AIRCRAFT: Husky A-1B

SUBJECT: Flap Cable Link

MODELS AFFECTED: S/N 2397-2418

Figure 1 Flap System Diagram

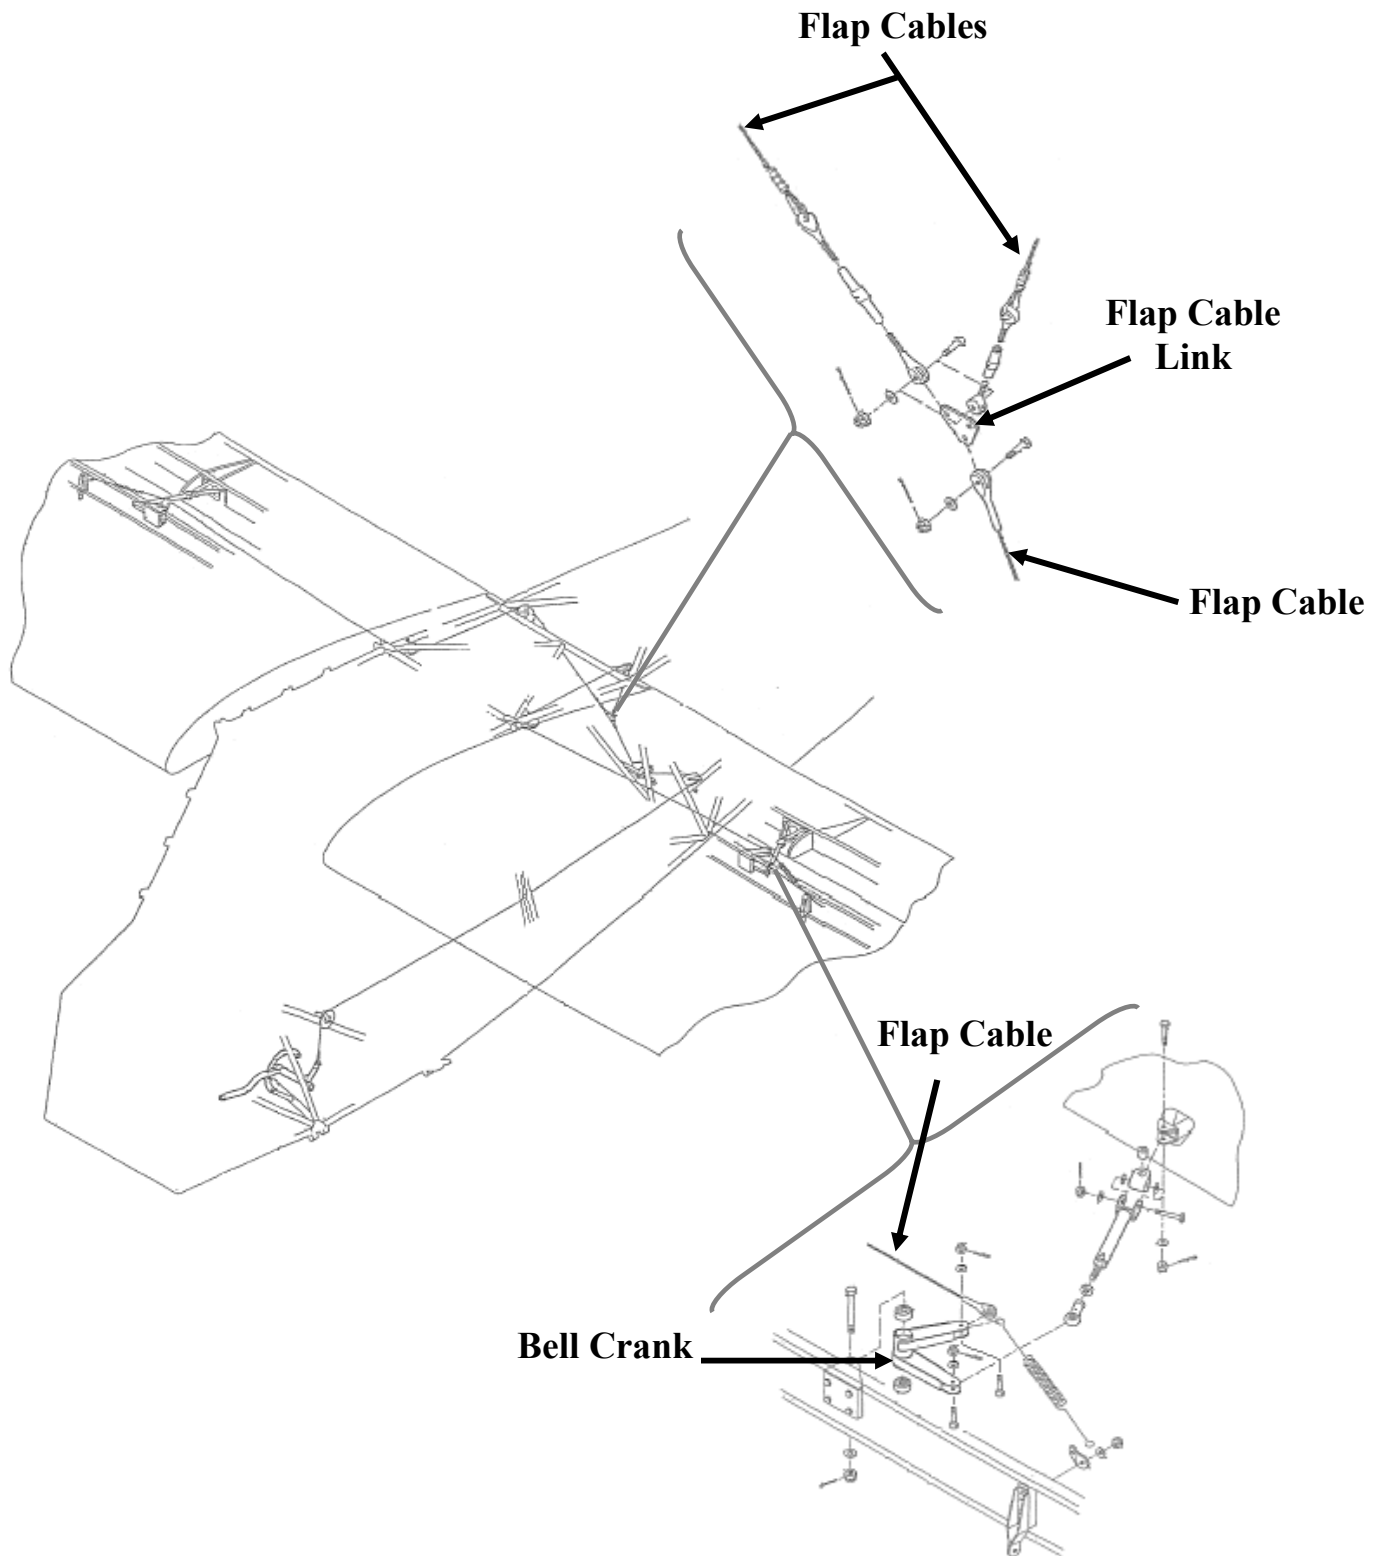
During a routine inspection of a specific aircraft, it was found that the flap cable link (part number 35064-001) was fabricated from incorrect sheet stock. The link was made from 0.050" 4130N while the link should have been made from 0.100" 4130 N. This discrepancy affects Husky serial numbers 2397-2418.

Measure the flap cable link and determine if it is the appropriate thickness. See Figure 1. The part should have a base thickness (without paint) of 0.100 inches. Note that it is not necessary to remove the paint - the difference between a 0.100 inch part and a 0.050 inch part is great enough that the thickness of the paint does not affect the accuracy of the measurement.

If it is found that the flap cable link is one of the defective parts, a new link should be installed. The parts required to replace the link are available from Aviat Aircraft Inc. by requesting Kit# A-1B-521 and are as follows:

1. Undo the 5 cam locks and remove the left side access door and open the battery door.
2. Remove the bell crank access panels on the top of the wings (8 screws each, 1 on each wing).
3. On both sides of the airplane, disconnect the flap cable that attaches to the bell crank. This will release the tension in the cables.
4. Remove the cotter keys, bolts, nuts, and washers that attach the cables to the flap cable link (3 each) and remove the flap cable link.
5. Install a new flap cable link with new bolts, nuts, washers, and cotter keys (3 each).
6. Use 2 people to reconnect the flap cables. Have one person connect the cables to the bell cranks while the other person checks to make sure that the cables stay on the pulleys.
7. Close the battery door, attach the left side access door (5 cam locks), and attach both bell crank access doors on the tops of the wings (8 screws each).
